**NEW MEXICO
ENVIRONMENT DEPARTMENT**

**RE: RESPONSE TO NOTICE OF VIOLATION
WESTERN REFINING SOUTHWEST INC., GALLUP REFINERY
EPA ID # NMD000333211**

Figure 1. Section of Figure from 1990s RFI (Contact Wastewater System)

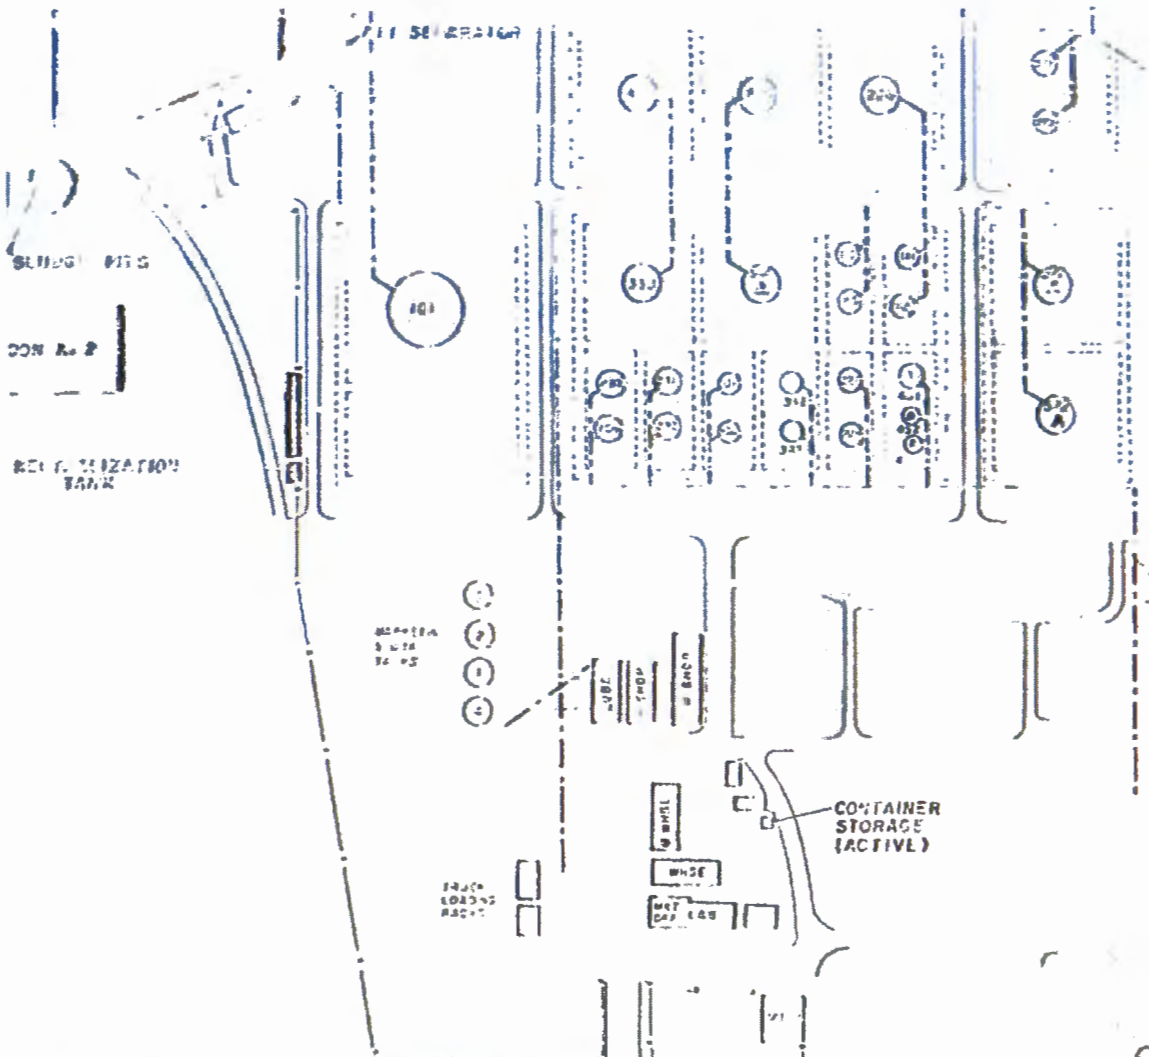
- In Section A (No RCRA Waste Listing is Applicable), Western states, "[t]he particular pipeline at issue in the NOV, referred to herein as the "truck rack line" (and sometimes described geographically by its proximity to above-ground units such as Crude Tank 102 or the bundle cleaning pad) carries an intermittent water flow originating from the truck rack, and is intersected by the instrument and electrical ("I&E") maintenance shop (described more fully in Section 11.C. below) and lab sink drains. The truck rack line, a portion of which was excavated and replaced, conveyed storm water and truck loading area wash water containing small quantities of gasoline and diesel drained from trucks and hoses into the sewer system. The I&E line contributed hand wash water and instrument testing water, and the lab sinks contributed bottle washings and unused or spent water samples and hydrocarbon samples. No process wastewater was discharged into the truck rack line from these sources, and no process wastewater would enter the refinery's sewer system until a point that was downstream of the replaced line. The sole sources of the contamination in the excavated media were associated with wastewater from the truck rack, the lab sinks, and the I&E maintenance shop." Based on a figure in a document titled "Stormwater Extension Project" dated October 2007 (Figure 2) and a figure from a RCRA Facility Investigation (RFI) conducted in the 1990s depicting the contact wastewater system (Figure 1), it appears that there is: 1) a stormwater drain pipe from the Process Area that connects to the Truck Rack Line south of the Heat Exchanger Bundle Cleaning Pad; and 2) there is a wastewater line from the Marketing Tanks, Transmix Loading Rack (which is not depicted on the figure, but is depicted on a Plant Layout map in the administrative record), and the Truck Loading Racks that connects to the Truck Rack Line. Therefore, it appears that process wastewater discharges into the Truck Rack Line, as well as wastewater containing slop oil.

- Western states that "[s]lop oil and solids are primarily produced at T-35, T-27, T-28, and the NAPIS, which are at least 1,056 feet downstream to the W/NW, and at least 200 feet lower elevation than the excavated truck rack line. The excavated truck rack line, thus, could not (and did not) contain slop oil or slop oil emulsion solids. Any materials associated with the subject truck rack line could not be K049." Based on the available figures, wastewater from the Transmix Loading Rack and Marketing Tanks appears to be conveyed to the Truck Rack Line. Transmix is slop oil, and therefore it appears the Truck Rack Line contained wastewater that carried slop oil and the excavated section of pipeline and associated soils contained K049 listed wastes.
